Application for Variation of an Environmental Permit

C1. Name of the Current Environmental Permit Holder :  
CLP Power Hong Kong Limited  
C2. Application No. of the Current Environmental Permit : FEP-01/341/2009/A  
C3. The Current Environmental Permit was Issued in : month / year  
04 / 2021

# Hong Kong Offshore Wind Farm in Southeastern Waters

Environmental Review Report for Proposed Cable Route

Figure 1.3

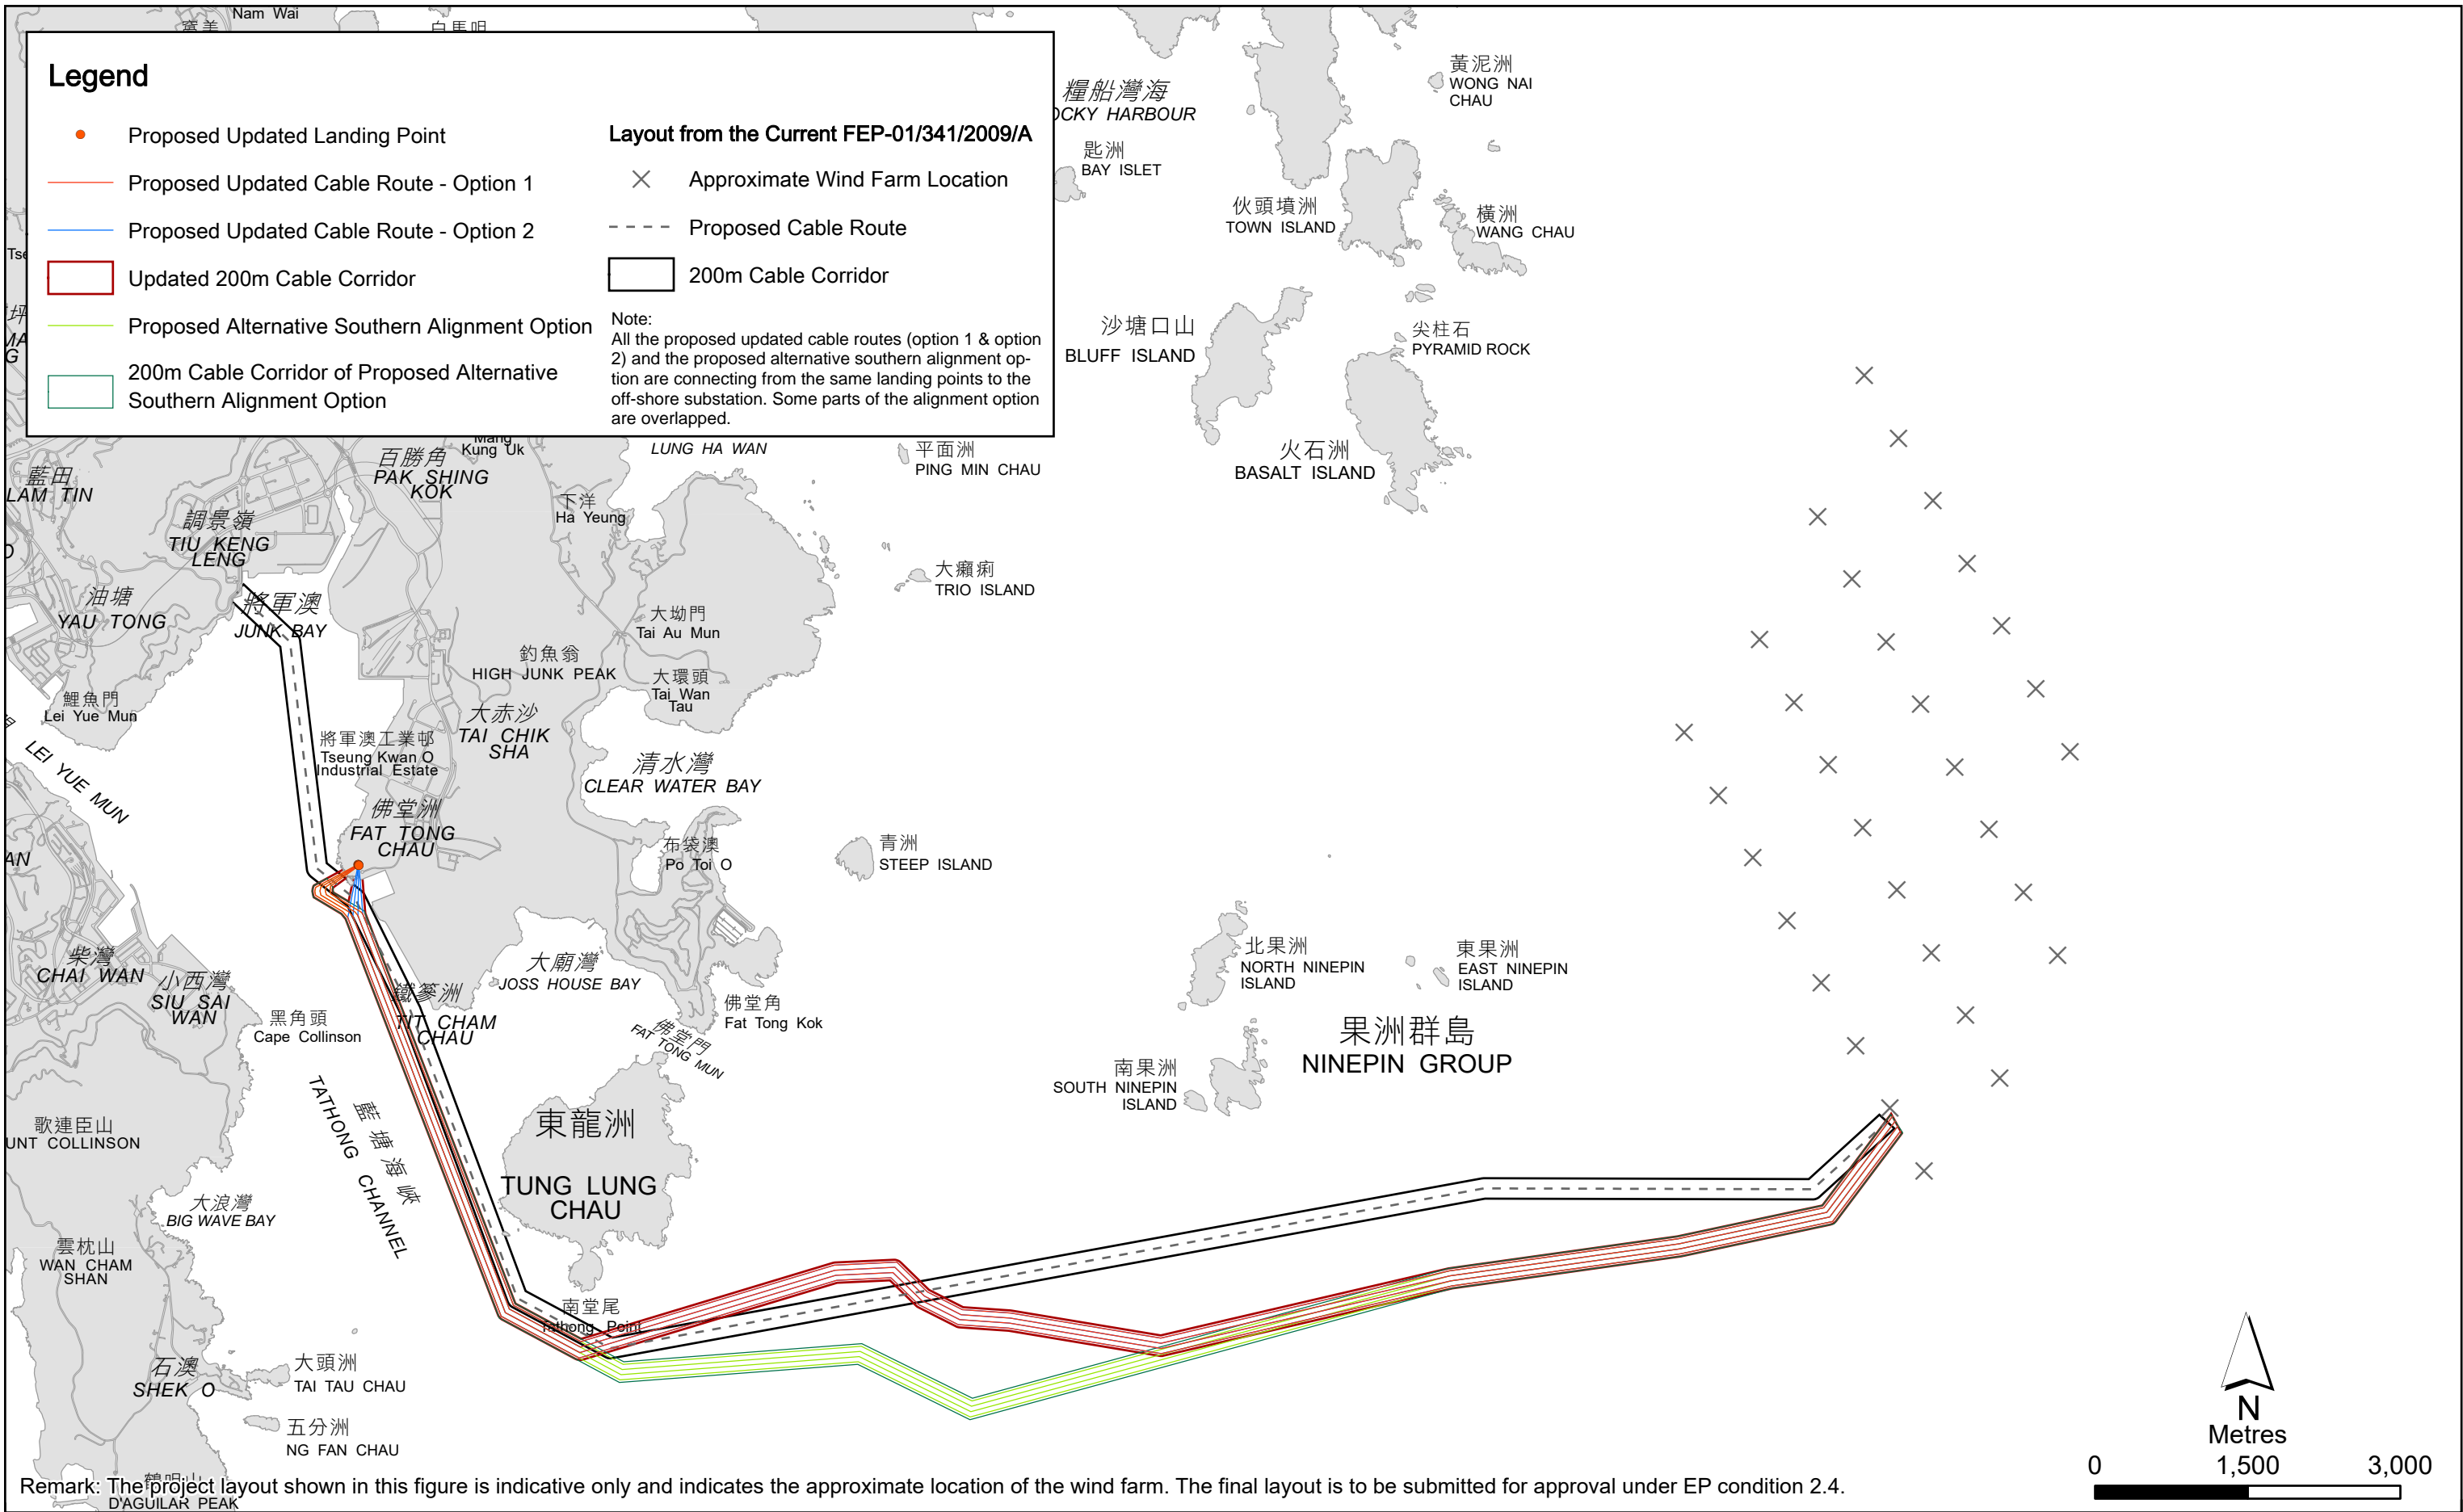
Condition	Current FEP	Proposed Variation	Reason for Variation
Figure 1	Location Plan (see <b>Figure 1.1</b> of the Environmental Review Report (ERR))	To be replaced with <b>Figure 1.2</b> of the ERR.	Following the proposed changes in scale and scope described below.
Condition 2.4	The Permit Holder shall submit to the Director for approval, at least six months before the commencement of construction of the Project, three hard copies and one electronic copy of the final layout of the wind farm turbines with demonstrations that the final layout, among the possible alternative layouts, has minimized the footprint of the project and maximized the distance of the turbines from Ninepin Group and Ung Kong Group.	The Permit Holder shall submit to the Director for approval, at least six months before the commencement of construction of the Project, three hard copies and one electronic copy of the final layout of the wind farm turbines, <u>cable alignment and location of cable landing site</u> with demonstrations that the final layout, among the possible alternative layouts, has minimized the footprint of the project and maximized the distance of the turbines from Ninepin Group and Ung Kong Group.	The final wind farm layout; cable alignment and cable landing site shall be confirmed by the Project Proponent at detailed design stage prior to the commencement of construction of the Project.

Figure 2.3

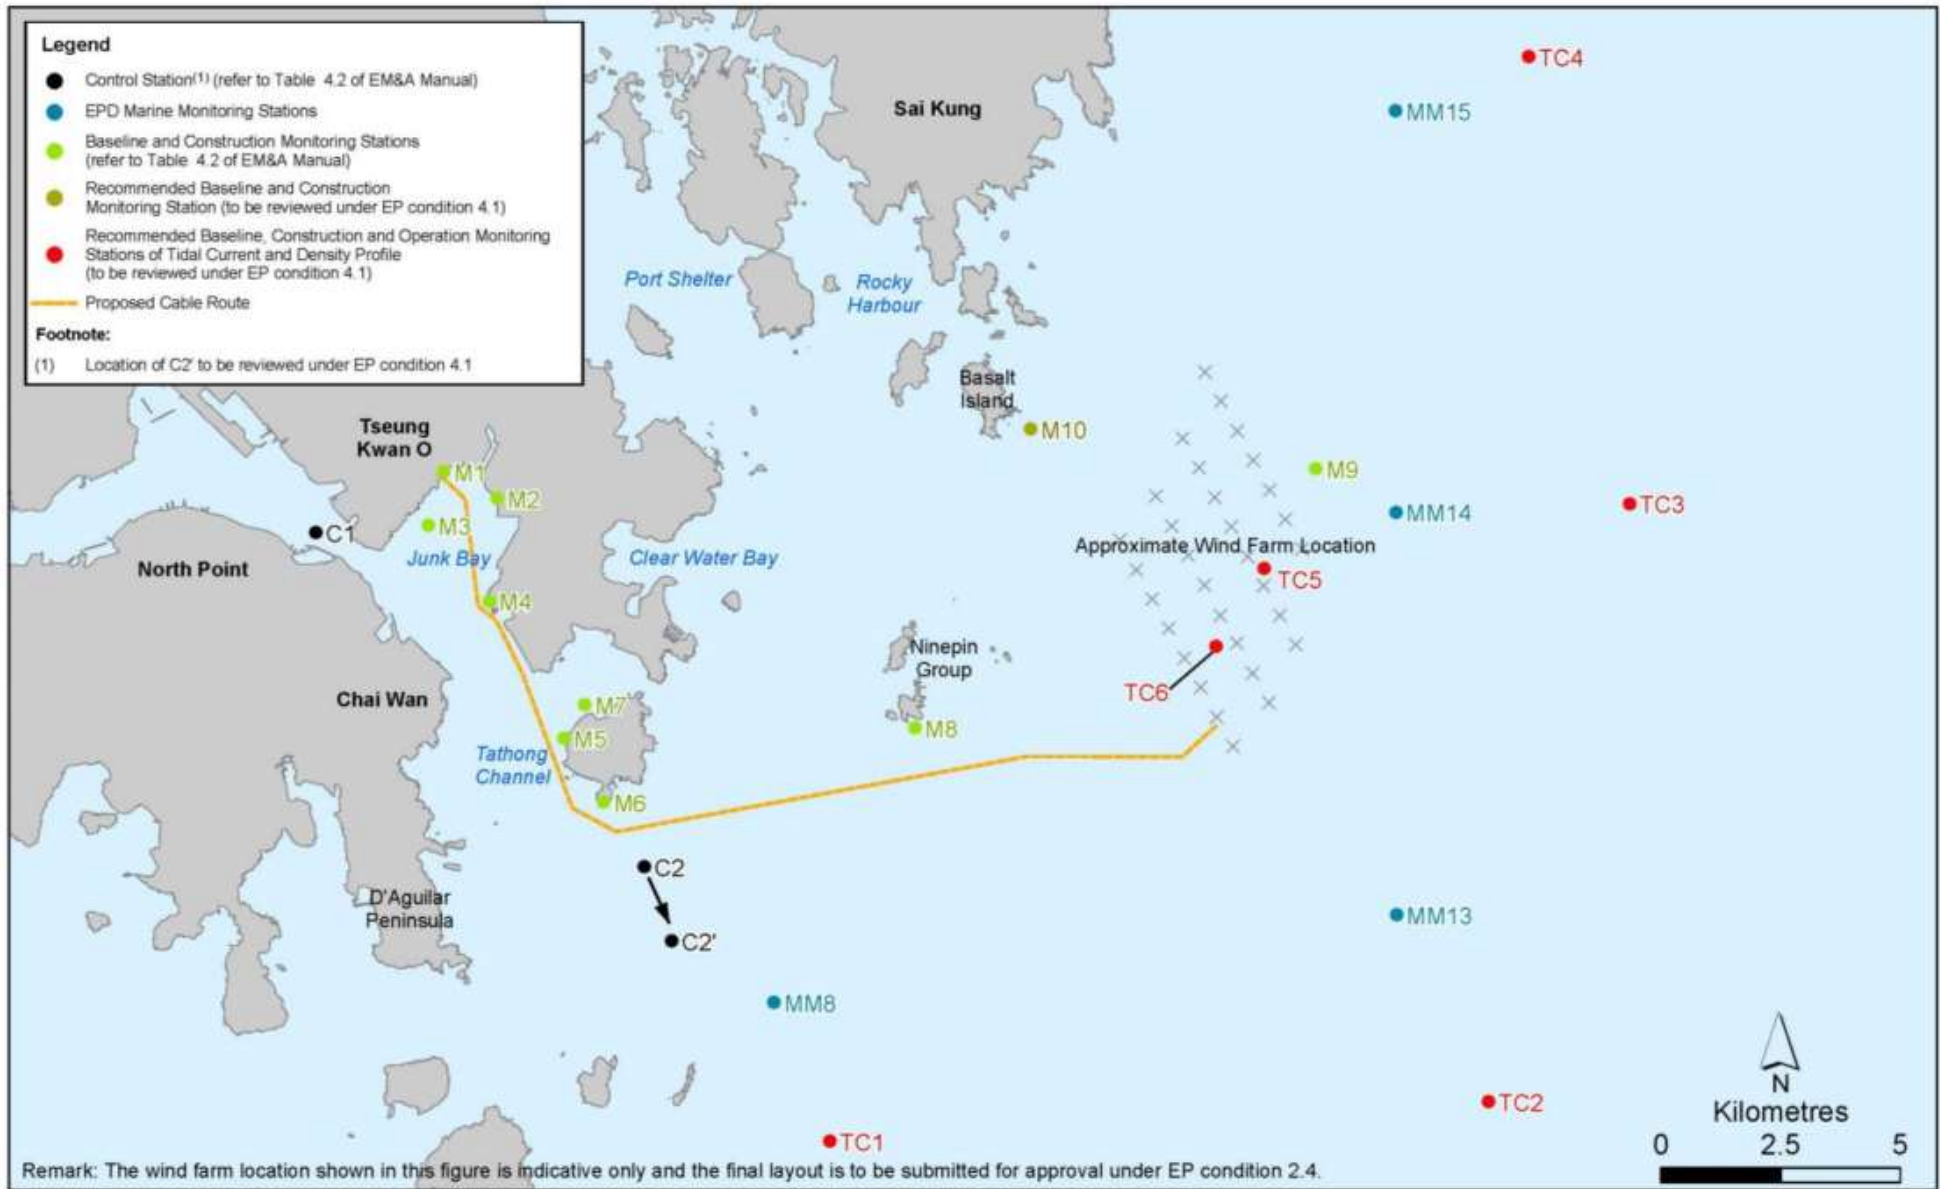
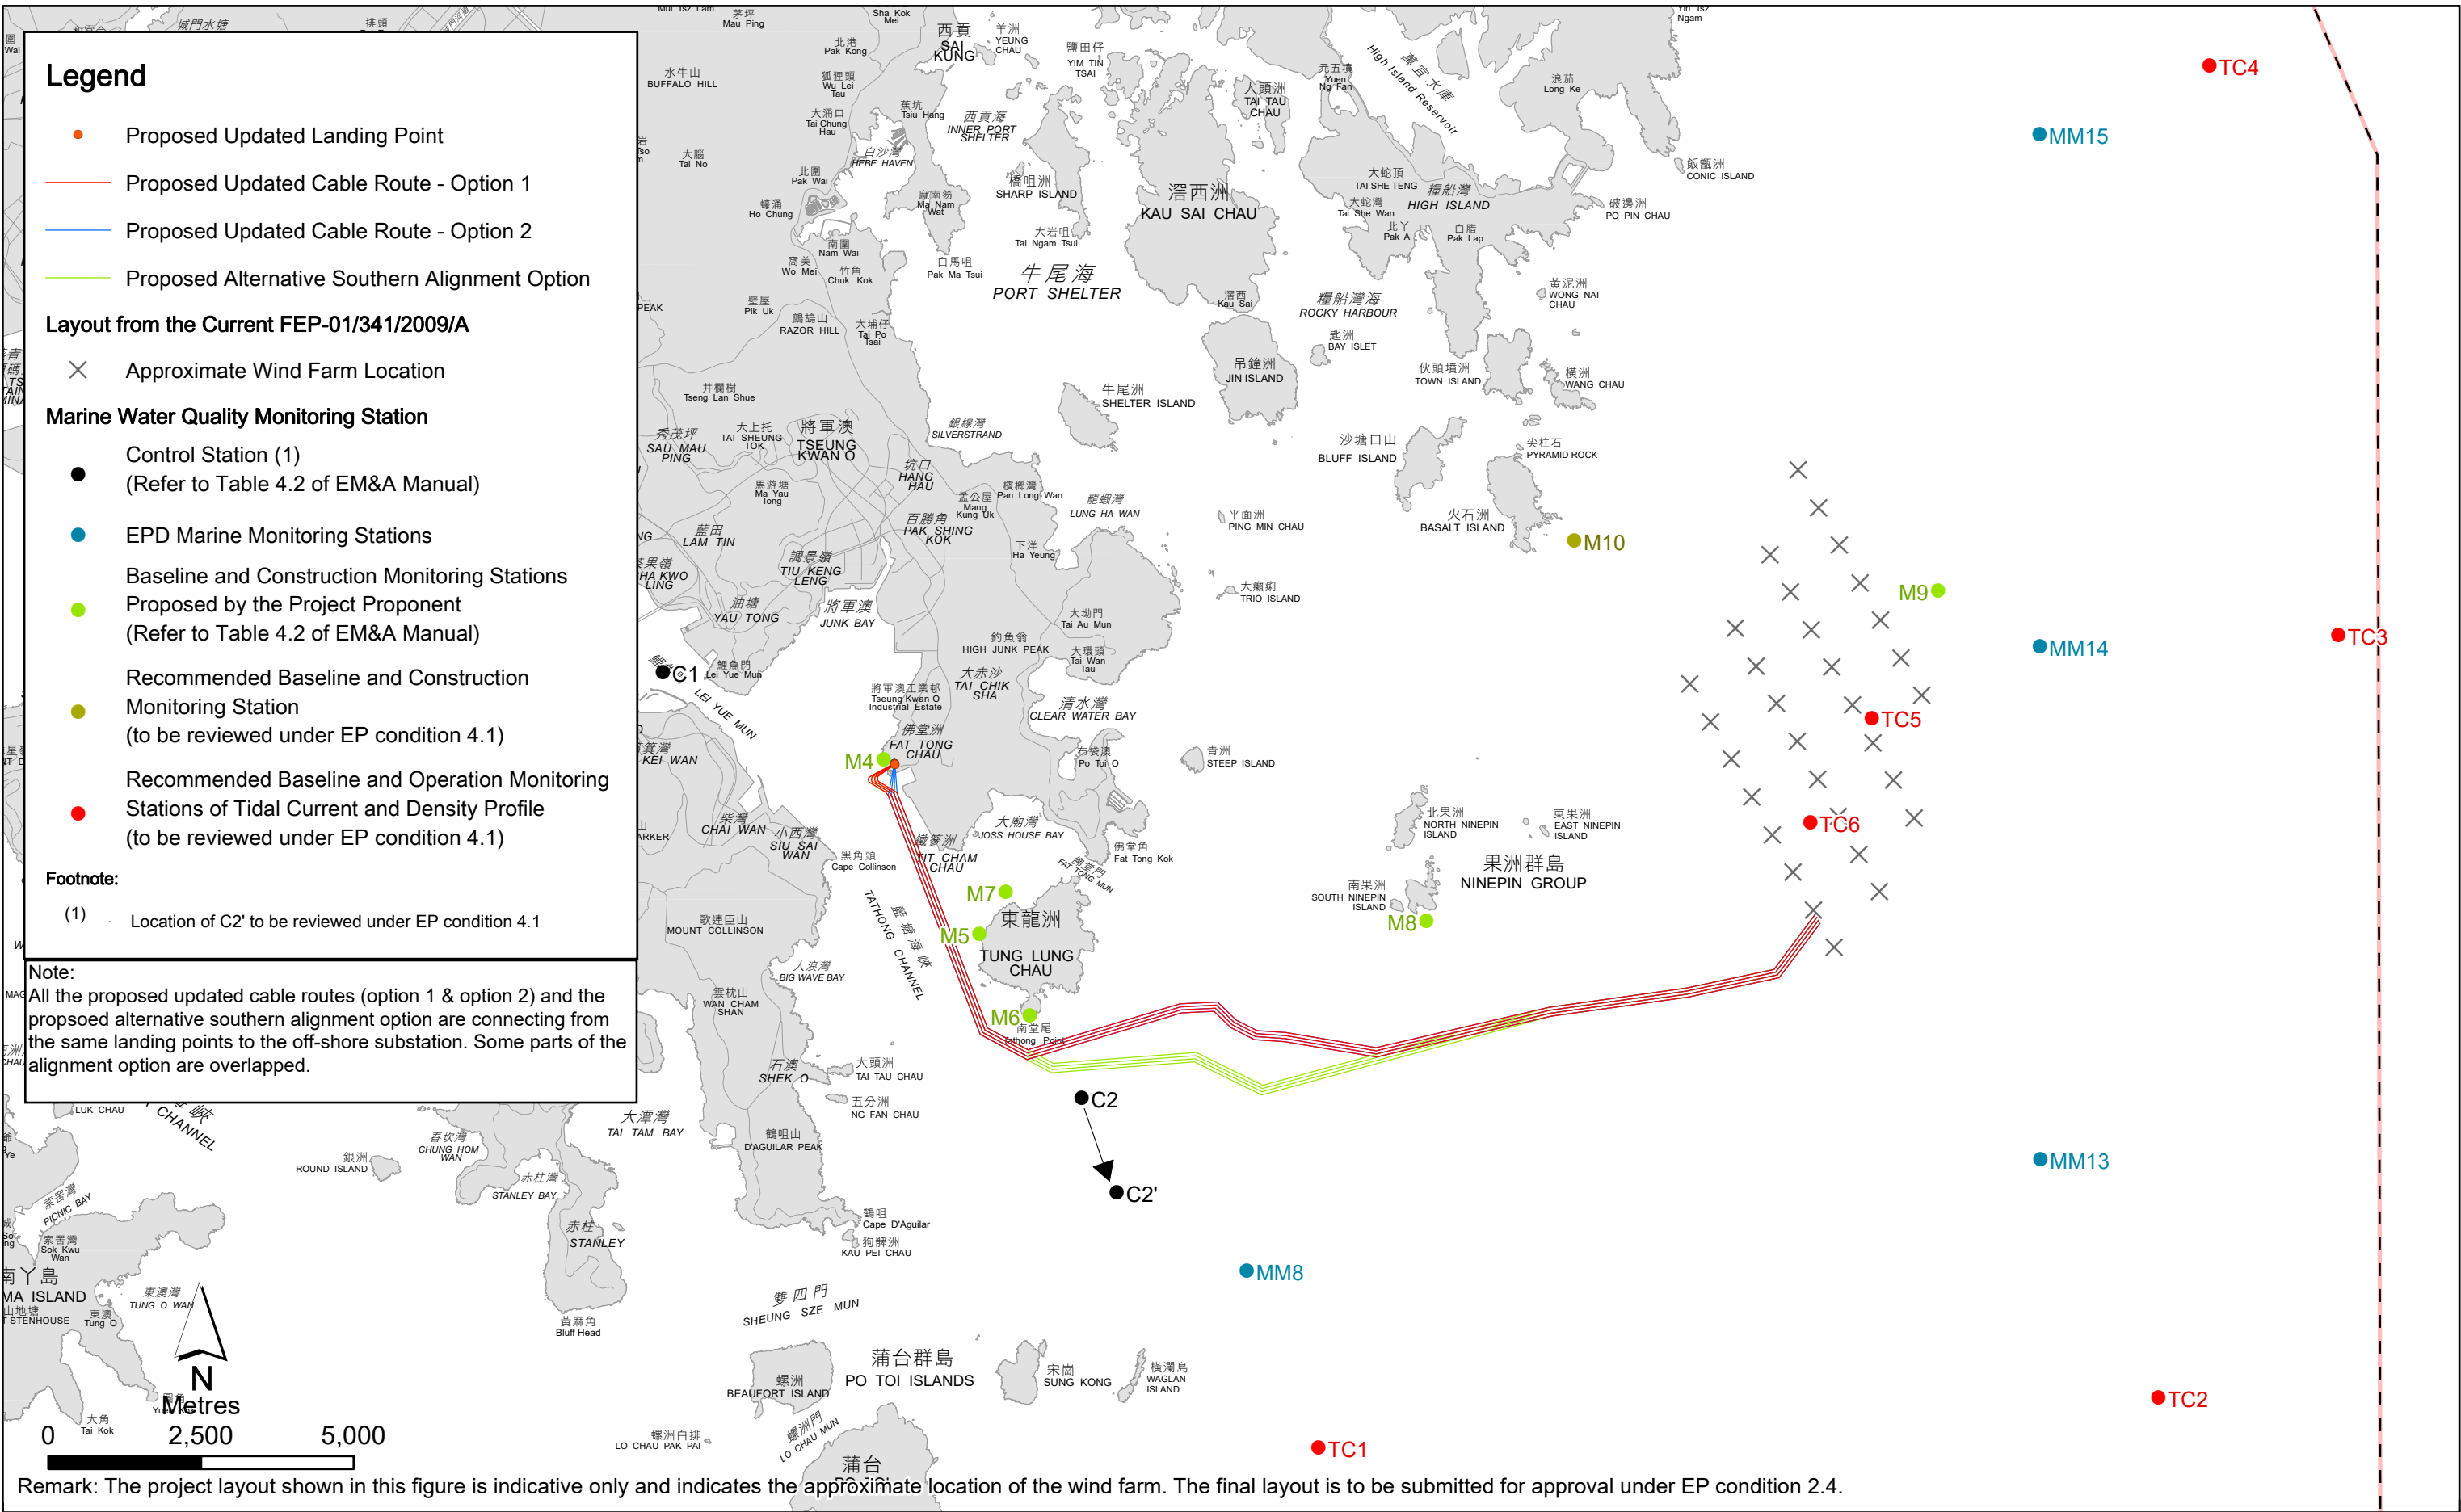
Condition	Current FEP	Proposed Variation	Reason for Variation
Figure 6	Locations of Marine Water Quality Monitoring Stations (see <b>Figure 2.3</b> of the ERR)	Figure 6 to be revised (to be replaced with <b>Figure 2.4</b> of the ERR)	Monitoring stations of M1 to M3 are not required as the cable route will not go inside Junk Bay.
-	-	<u>Proposed New Condition:</u> Submission of a monitoring proposal for AMO's agreement prior to the commencement of construction works.	The Fat Tong Chau SAI is located directly above HDD section of the proposed cable alignment.

Review of potential change in water quality impact due to construction works under *Section 3.4* indicated that notable change in water quality impact is not anticipated due to the updates in the project design and working rate. Therefore, the proposed water quality monitoring requirements (i.e. baseline monitoring and construction phase monitoring) stipulated in the EM&A Manual are still deemed applicable and sufficient, except the water quality monitoring stations of M1 to M3 are omitted as the cable route will not go inside Junk Bay.
